DATE: January 30, 2026

ADDENDUM NO. 4

PROJECT NO. DGS C-0946-0012 PHASE 006
PROJECT TITLE - PA State Museum & PHMC Tower - Infrastructure Upgrades and Renovations
PROFESSIONAL:
Design Resources Group Architects AIA
270 Davidson Ave, Suite 303
Somerset, NJ, 08873

DRAWN BY	DATE	DRAWING NUMBER
KEH	10/10/2025	MD101
CHECKED BY	SCALE	
DC	1/8" = 1'-0"

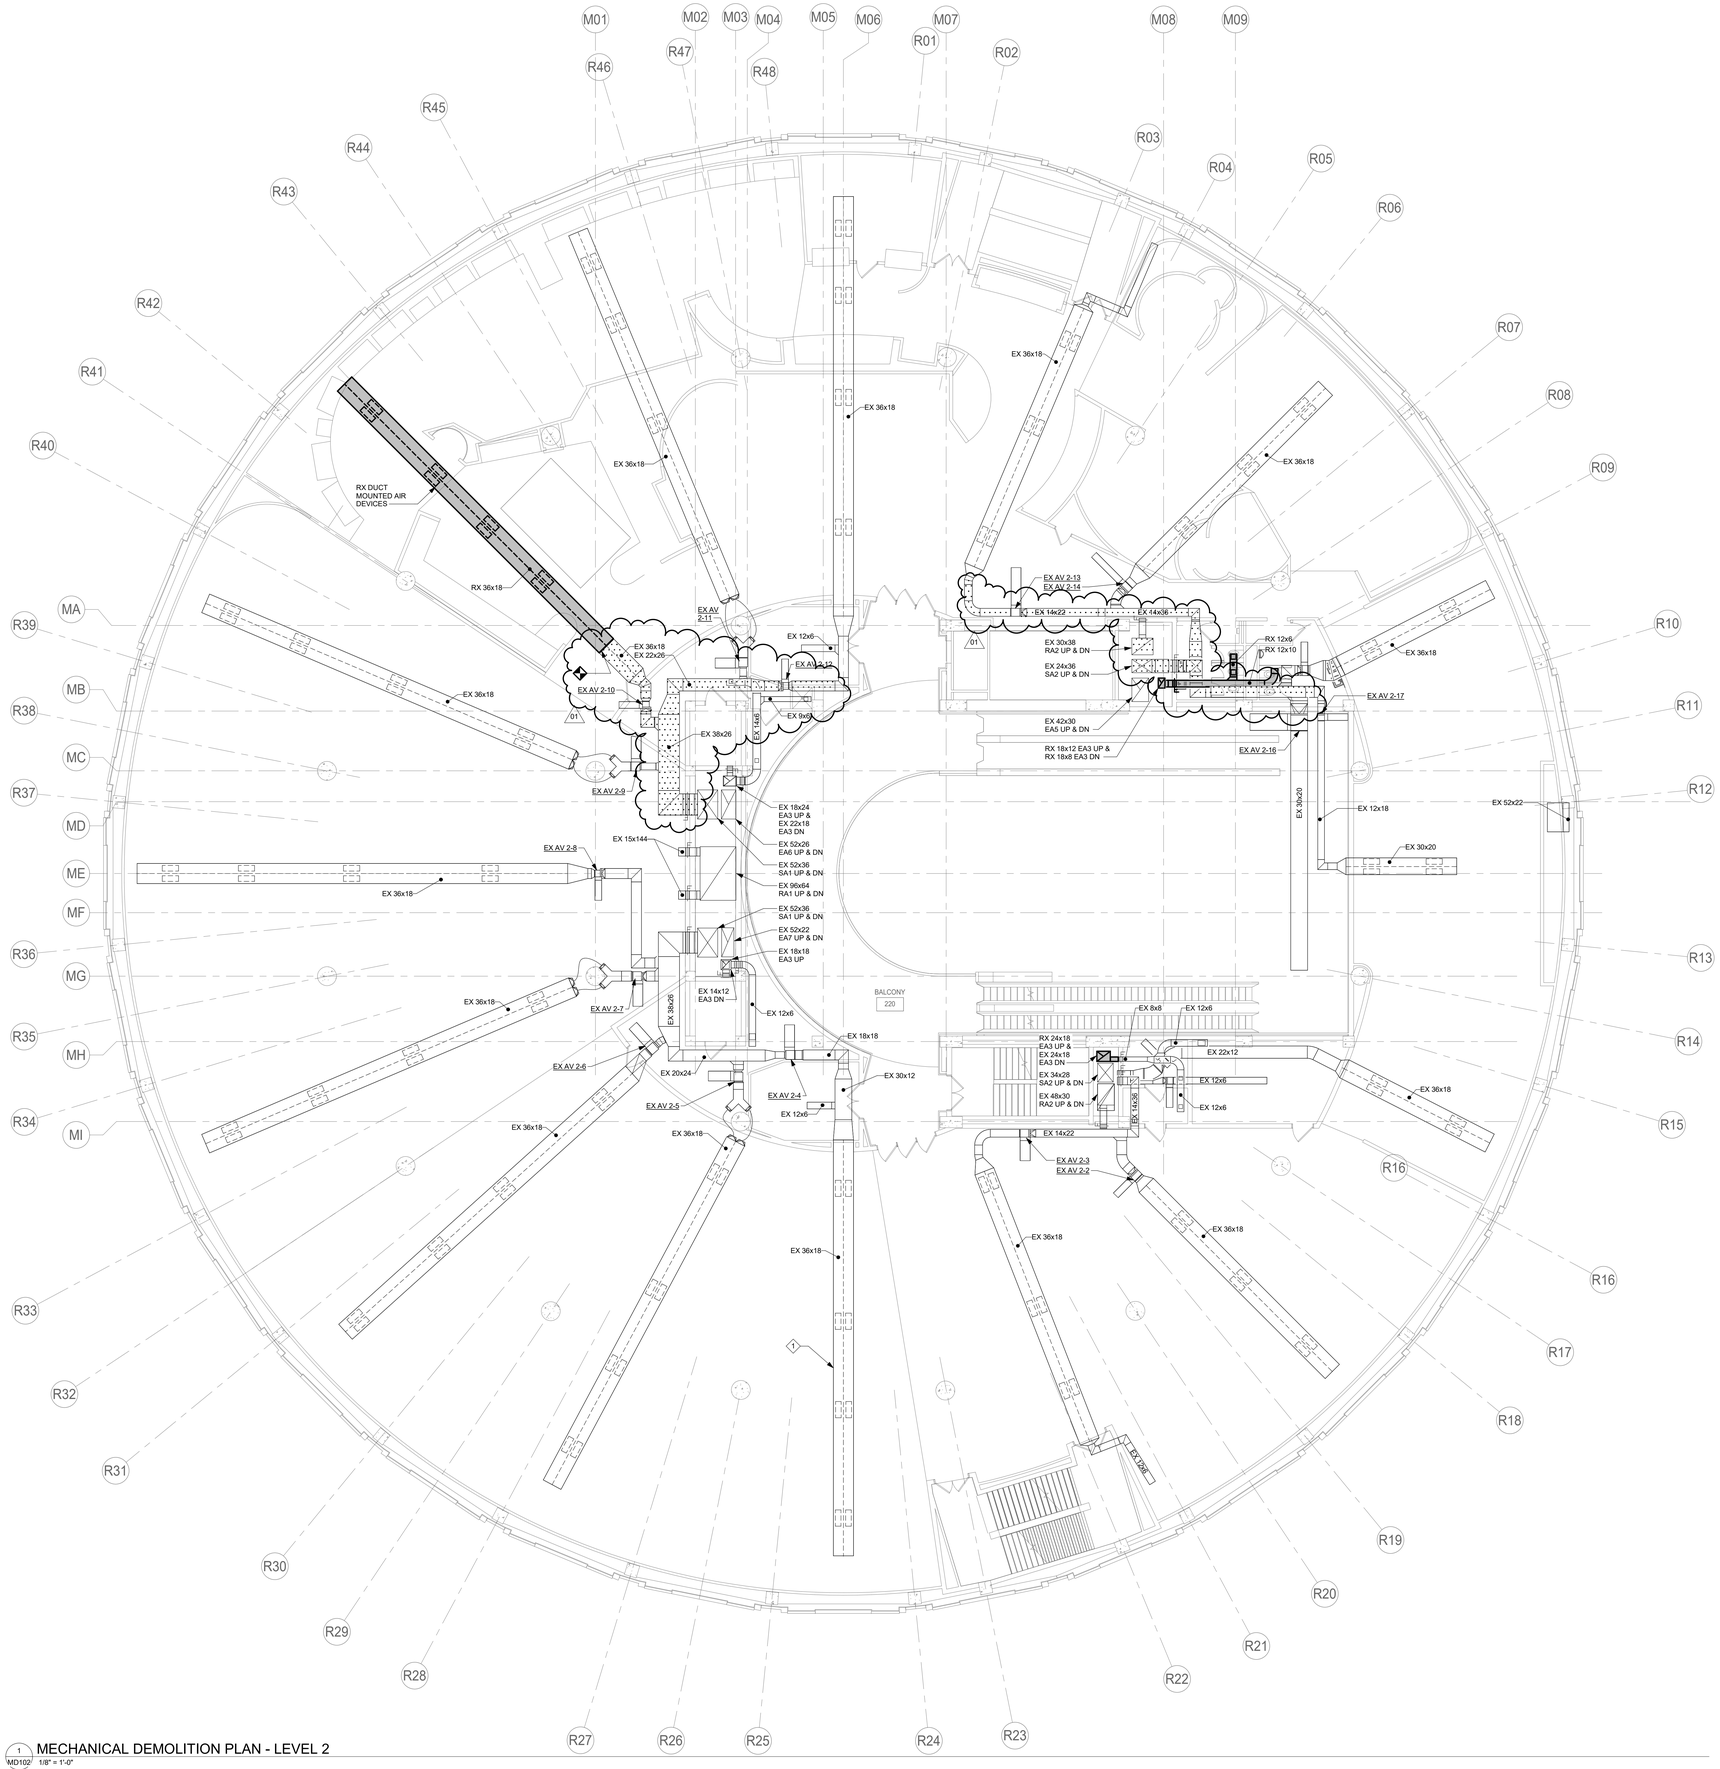
Item 64 - Drawing MD101 - Showed the extent of existing ductwork to be cleaned.

DRAWN BY	DATE	DRAWING NUMBER
KEH	10/10/2025	MD102
CHECKED BY	SCALE	
DC	1/8" = 1'-0"

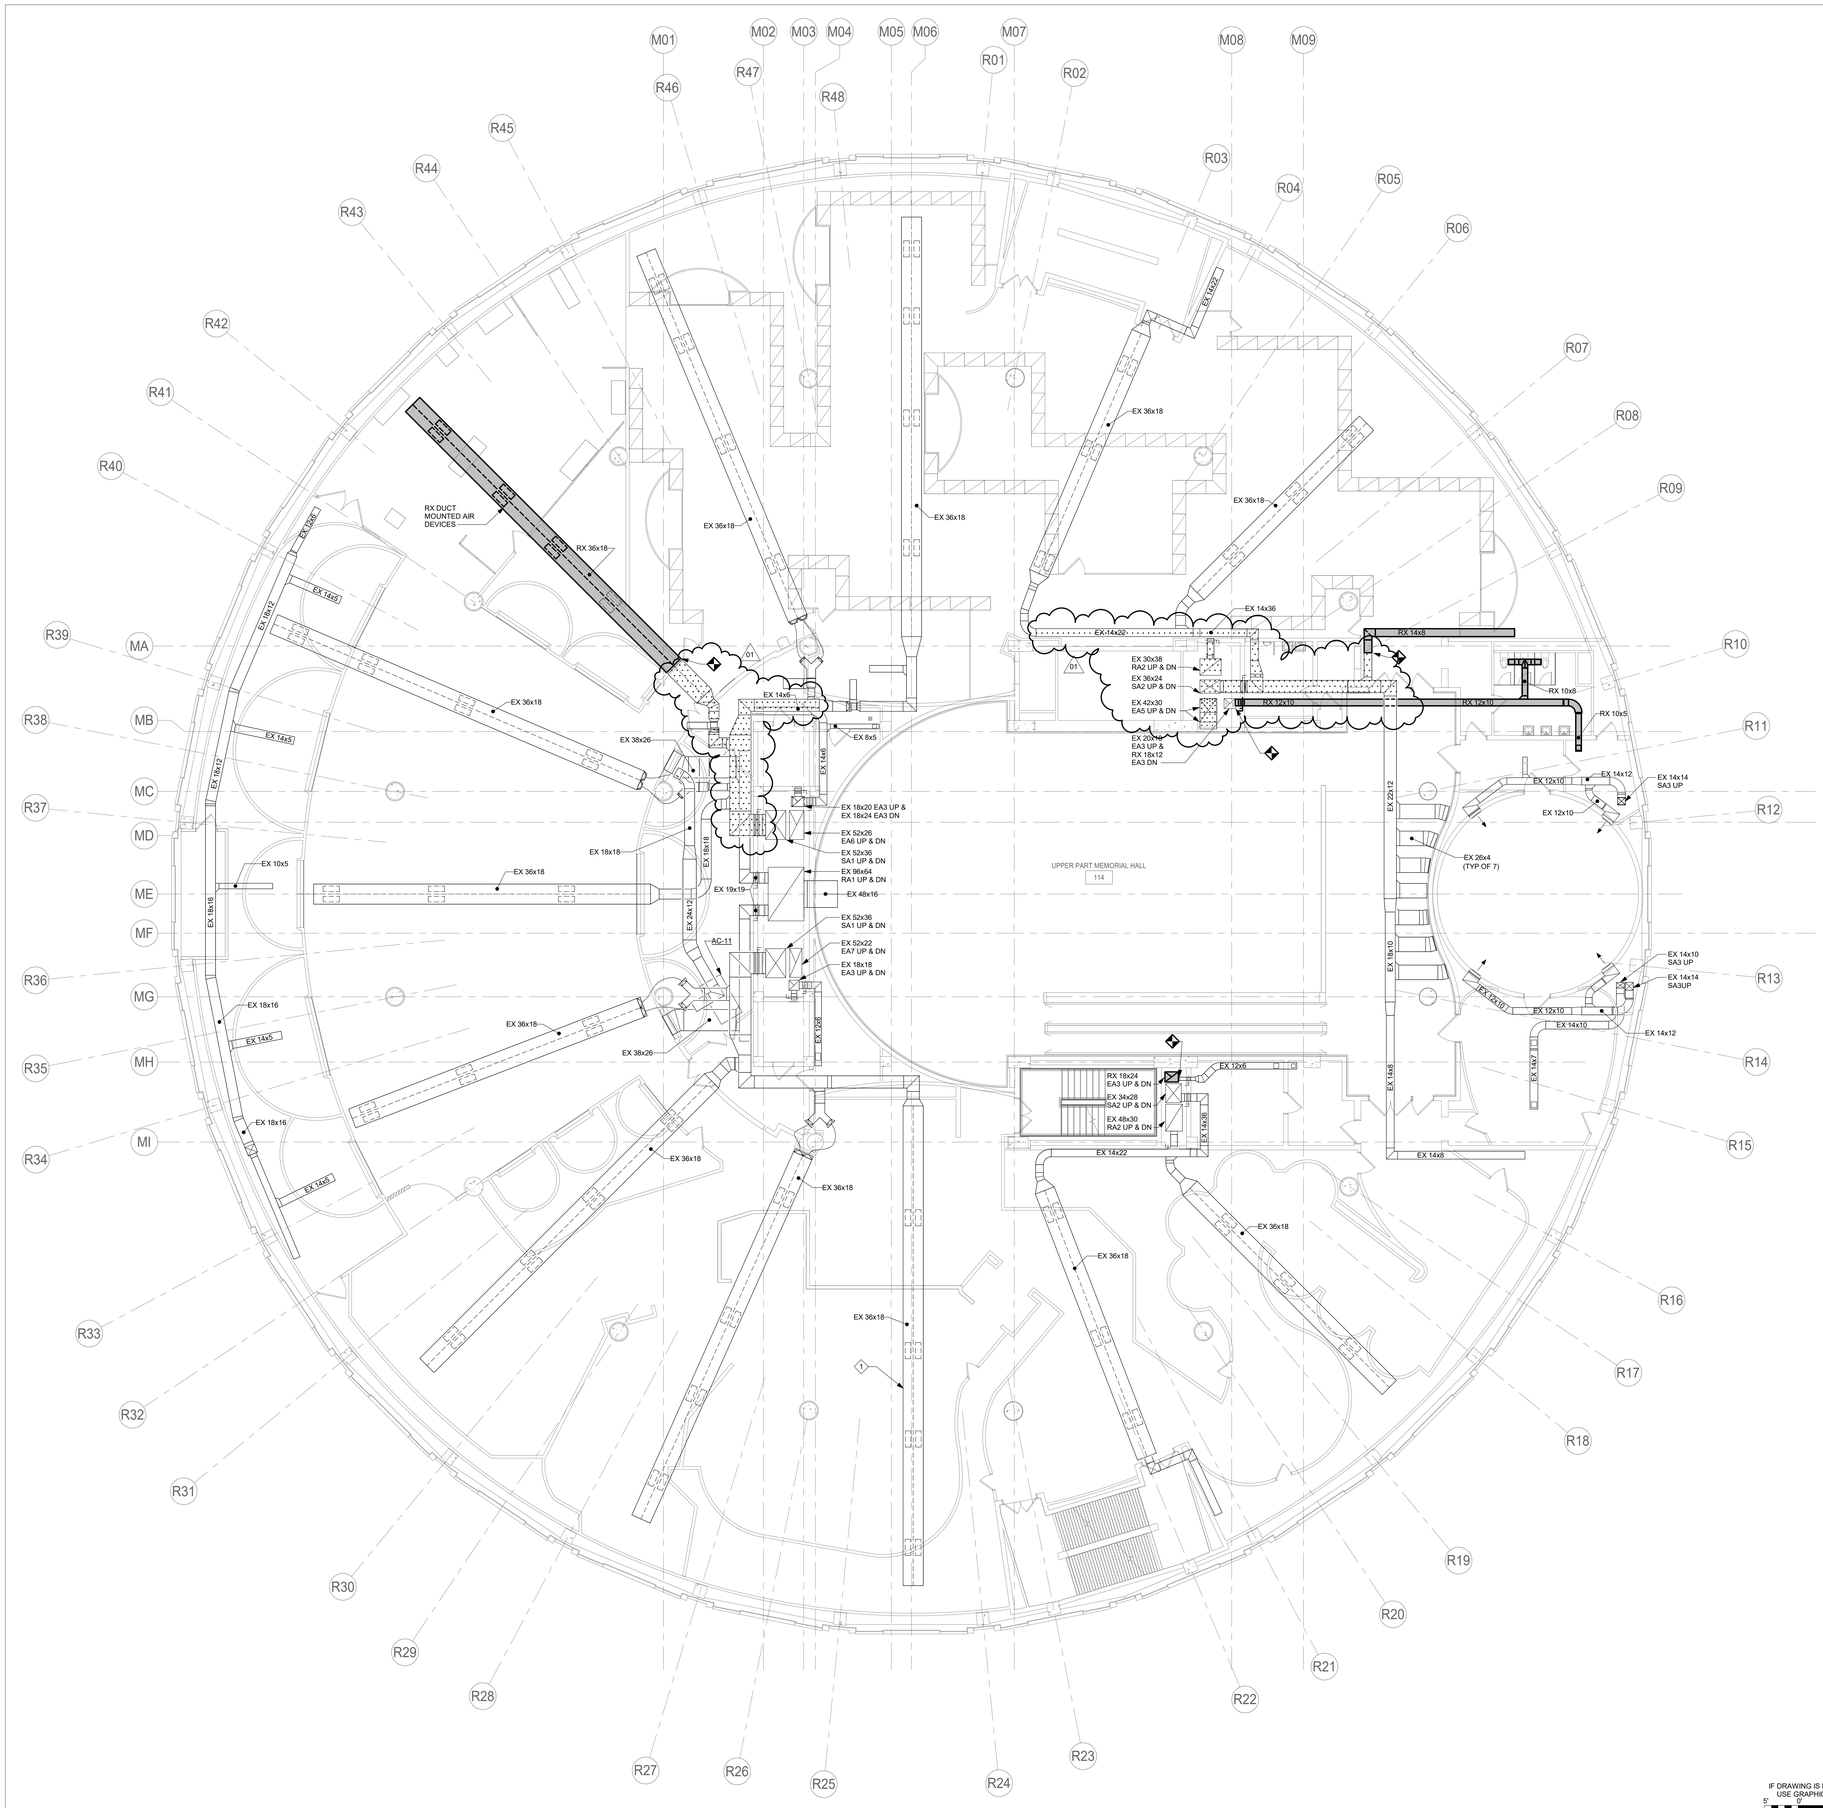
Item 65 - Drawing MD102 - Showed the extent of existing ductwork to be cleaned.

DRAWN BY	DATE	DRAWING NUMBER
KEH	10/10/2025	MD103
CHECKED BY	SCALE	
DC	1/8" = 1'-0"

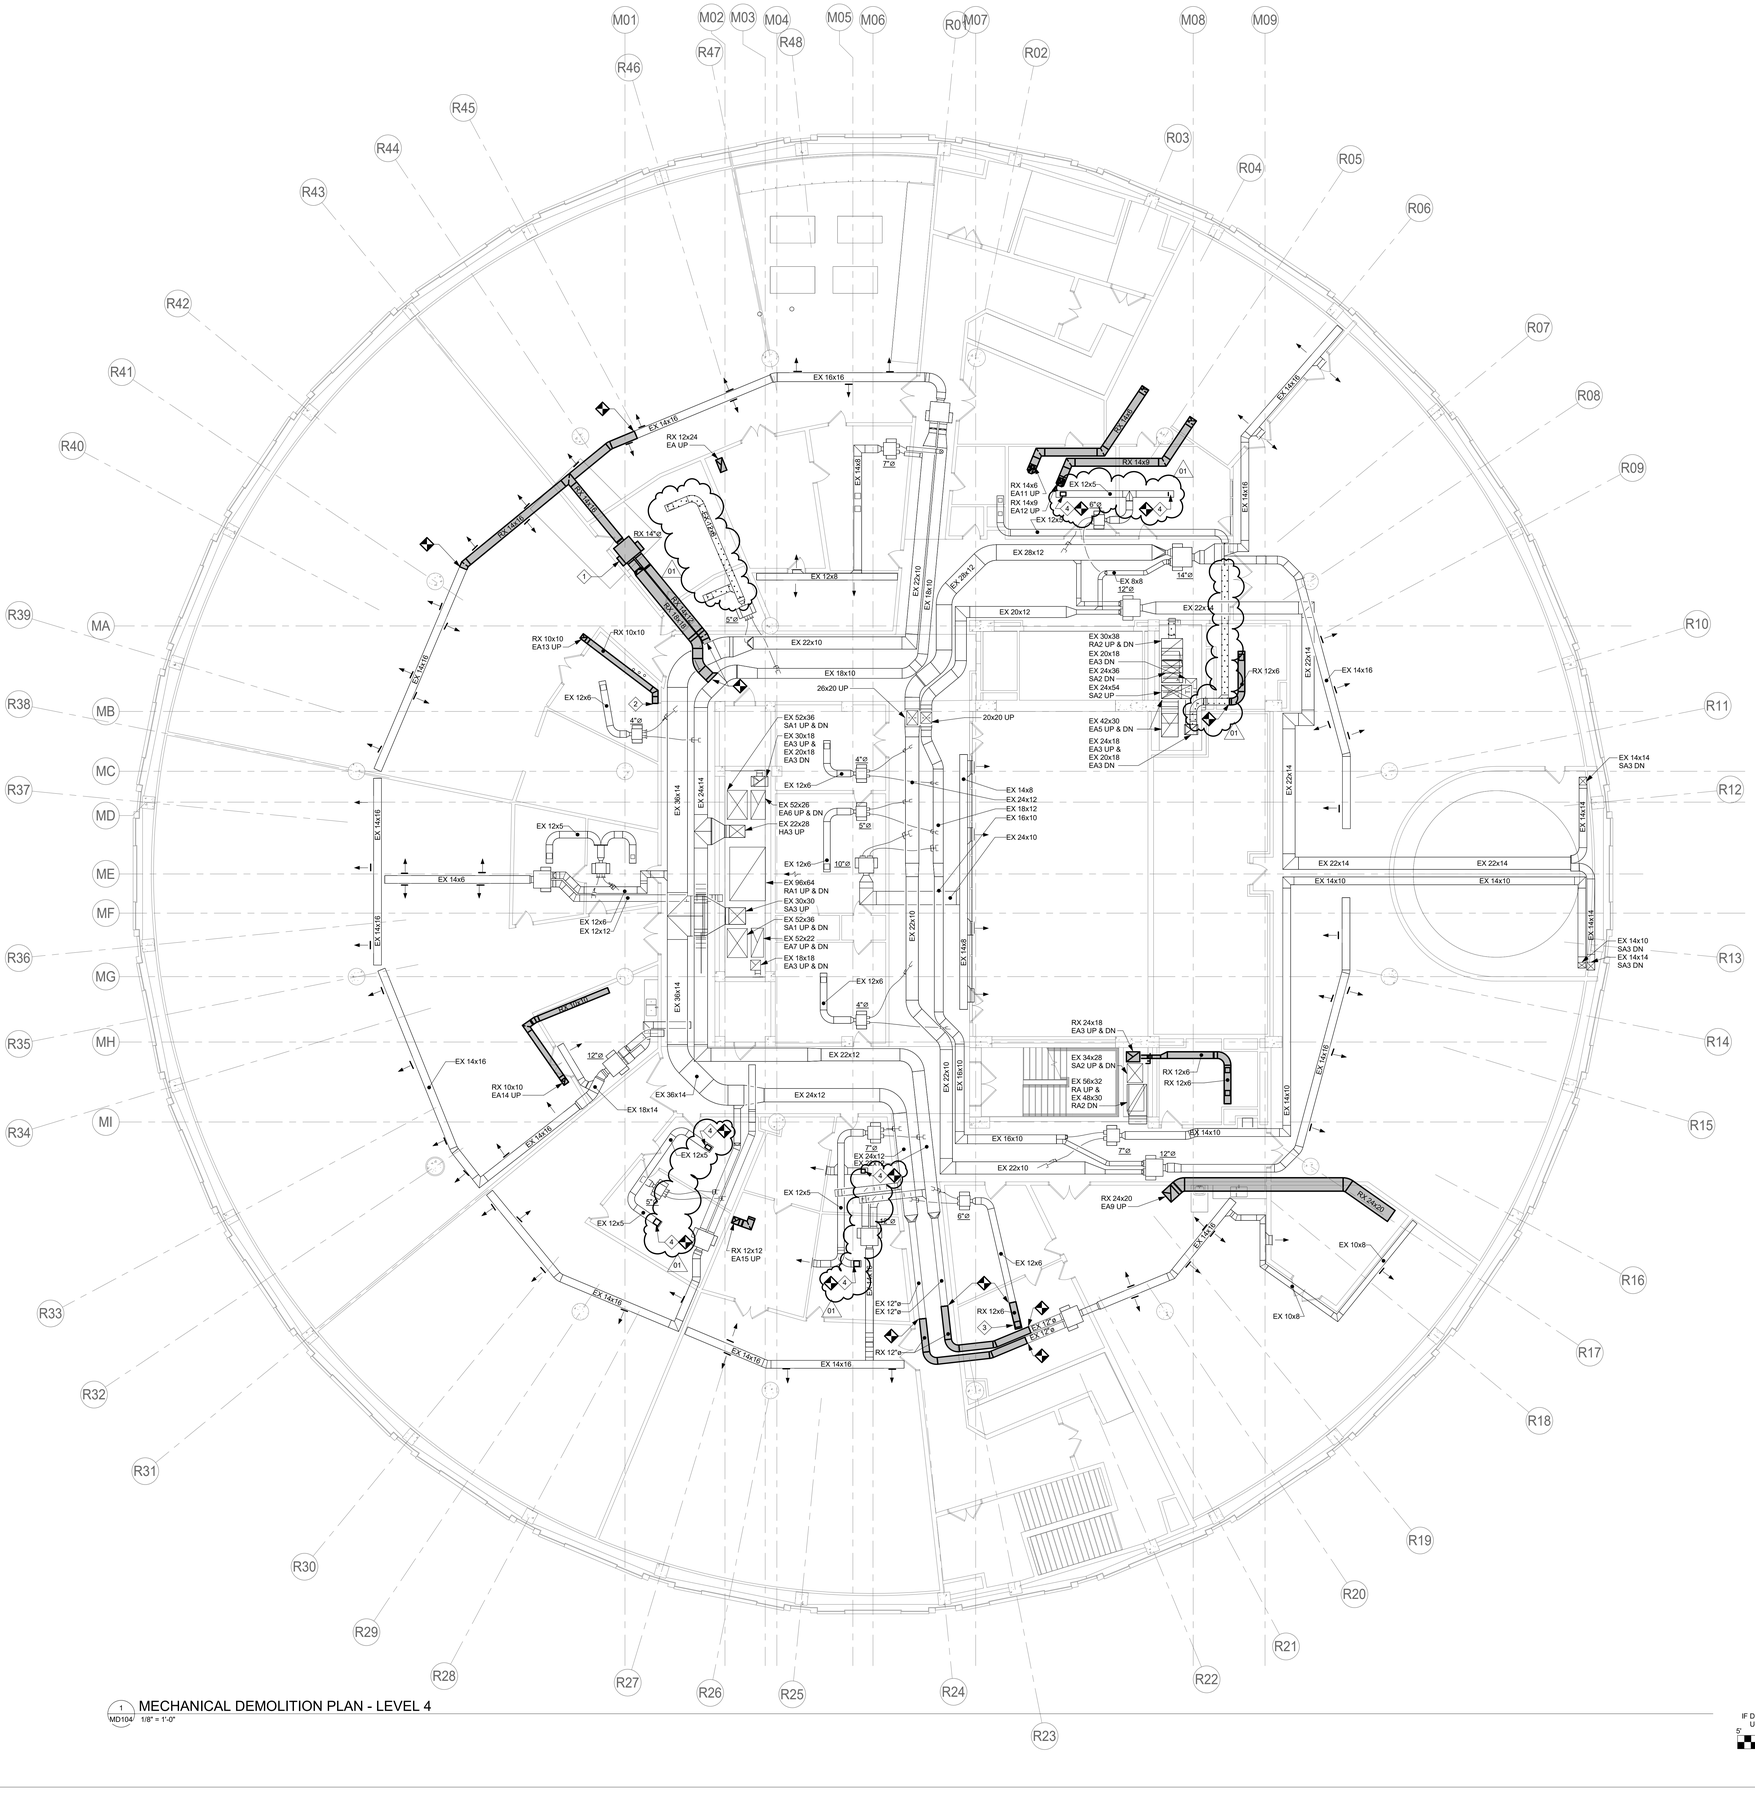
Item 66 - Drawing MD103 - Showed the extent of existing ductwork to be cleaned.
